Rosefield Solar Farm

Design Commitments (~~Clean~~Tracked)

EN010158/APP/5.9.~~7~~8
Revision 0~~8~~7
Deadline ~~56~~
~~July-August~~ 2026
Rosefield Energyfarm Ltd

TITLE:
APPENDIX 1: DRAFT ANIMAL MOVEMENT AREA PLAN

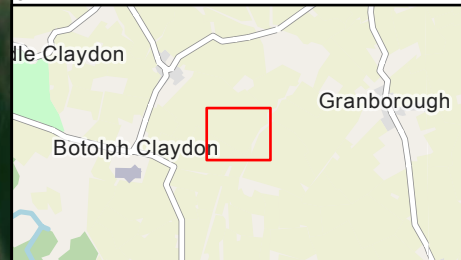
- 1.1.2. This document has been updated at Deadline ~~65~~ to ~~amend-update design commitment G2~~the Draft Animal Movement Areas Plan at Appendix 1 following ongoing discussion with Preston Farms Limited and to ~~add design commitment D26 on Environmental Colour Assessment in response to Action Points 7 and 8 of Issue Specific Hearing 3~~revise the wording of design commitments G2 following ongoing discussions with the landowner and G3 following ongoing discussion with the tenants. References to other application documents have not been updated from the original submission. Please refer to the **Guide to the Application [EN010158/APP/1.2.124]** for the list of current versions of documents.

Notes:
Gaps would be created through the early planting where required at gateways to allow movement of animals through them. Width of gap to be agreed with Preston Farms Ltd and TCS Bioscience Ltd.

Boundary treatment between animal arc and Solar PV development to be designed in discussion with Preston Farms Ltd and TCS Bioscience Ltd at the detailed design stage.
